**OCCUPATIONAL SAFETY
AND HEALTH STANDARDS BOARD**

SECOND NOTICE OF PROPOSED MODIFICATIONS TO
CALIFORNIA CODE OF REGULATIONS
TITLE 8: Division 1, Chapter 4, Subchapter 4, Article 2,
Sections 1504 and 1591 and New Appendix A of the Construction Safety Orders

Vehicle Exhaust Retrofits

Proposed Further Modifications To Second 15-Day Notice

Figure 1

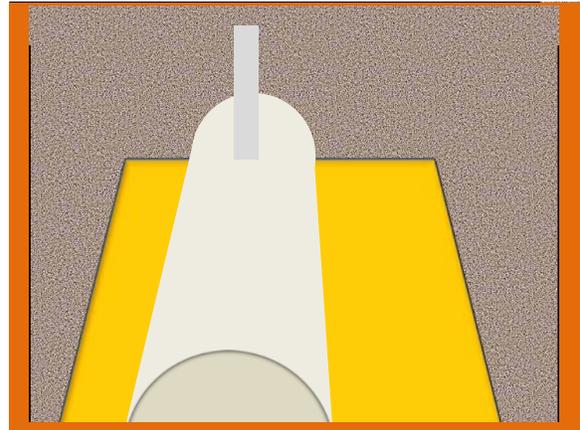
- (i) The retrofit section is below the driver's view to the edge of the vehicle (see Figure 1), or
- (ii) The retrofit section does not block the driver's view of the rectangular boundary line drawn according to subsection B.2.b.

Figure 2

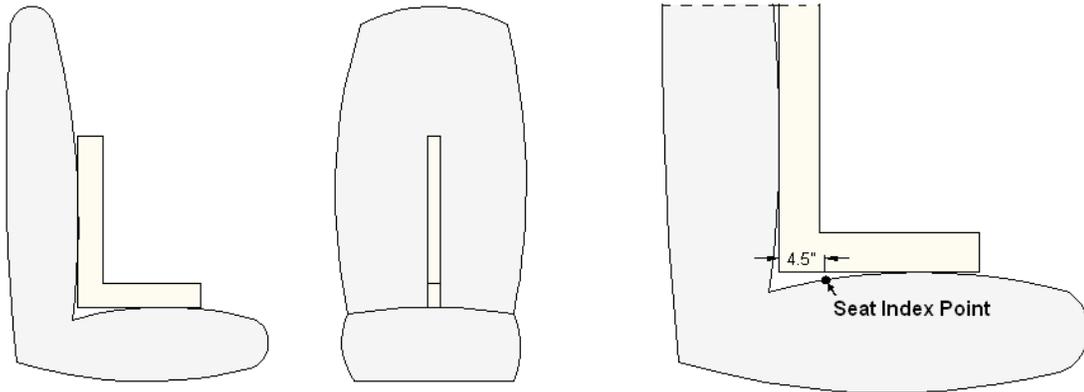
- e) Use a carpenter's square to locate the seat reference point, as follows (see Figure 2):**
 - (i) Rest the edge of one arm of the carpenter's square on the seat cushion such that it is level and bisects the seat from left to right.**

- (ii) Position the other arm of the carpenter's square such that it is vertical and its edge touches the most forward part of the seat backrest.**
- f) Mark a point on the center line of the seat 4 inches in front of the most forward part of the backrest. This point is the seat reference point.**

Figure 3

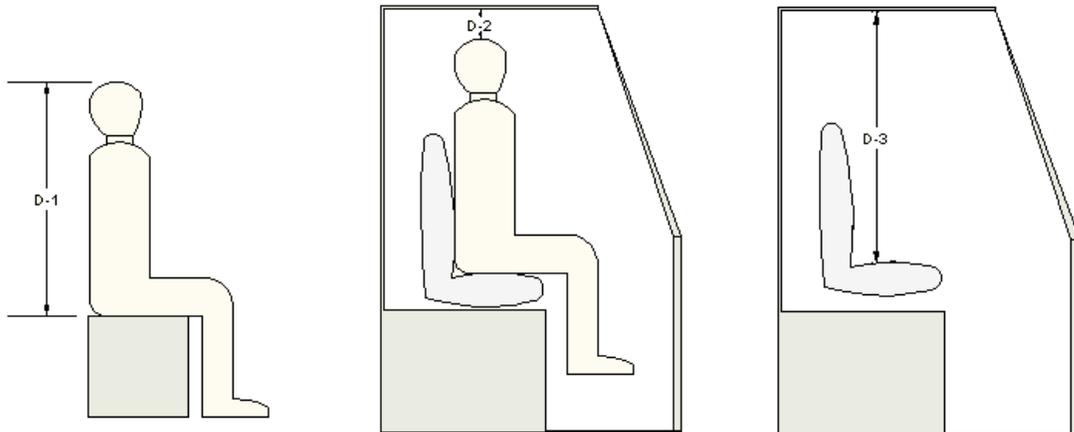
- a) Select a person weighing at least 195 pounds to represent the driver. The driver shall sit on a hard bench or similar surface that does not compress when sat on. Measure and record the distance from the seat surface to the top of the driver's head. This distance is represented by distance D1 in Figure 3.**

- b) With the driver seated upright in the driver's seat (with the seat adjusted as described in Section E.) measure and record the distance from the top of the driver's head to an overhead reference point directly above. This distance is represented by distance D2 in Figure 2. If an overhead reference point, such as a cab ceiling or a roll bar, is not available, construct an overhead reference point out of plastic pipe or other material.**

- c) With the seat unoccupied and adjusted as provided in Section E, measure the distance from the overhead reference point to the seat reference point. This distance is represented by distance D3 in Figure 3.**

- d) Calculate seat compression as follows:**
Seat compression = D1 + D2 - D3, as illustrated in Figure 3.
- 2. Calculate the camera lens height as follows:**
